American Honda Motor Co., Inc.

PRODUCT UPDATE NOTICE

BF200AK3 • BF225AK3 • BF250A Outboards

LEFT TIMING BELT DRIVEN PULLEY REPLACEMENT

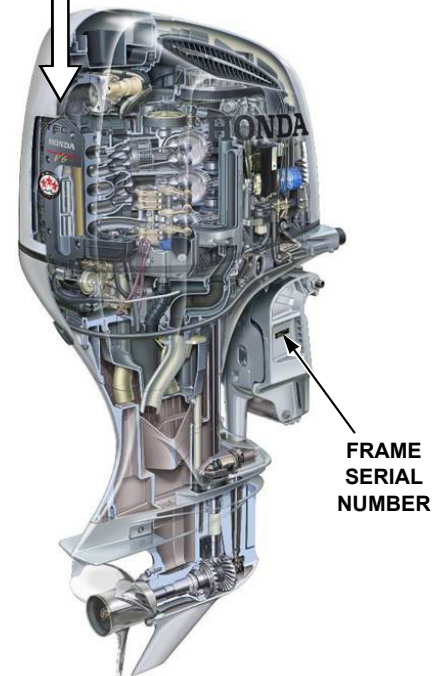
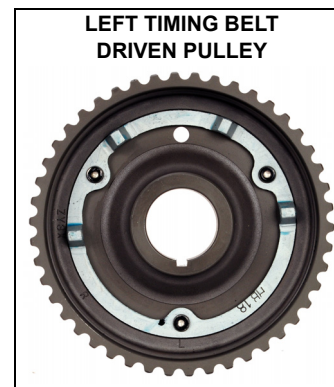
The left timing belt driven pulley may interfere with and damage the TDC sensor due to improper riveting on the pulley's sensor pick-up plate.

If the left timing belt driven pulley fails, the warning system buzzer on the outboard motor will sound and the engine will shut off and cannot be restarted.

Please contact your Honda Marine servicing dealer to make arrangements to have your BF200AK3, BF225AK3, or BF250A repaired. The dealer will replace the timing belt pulley and, if needed, the TDC sensor at no charge to you while the outboard is still under warranty. Transportation of the outboard to the dealer is the responsibility of the owner.
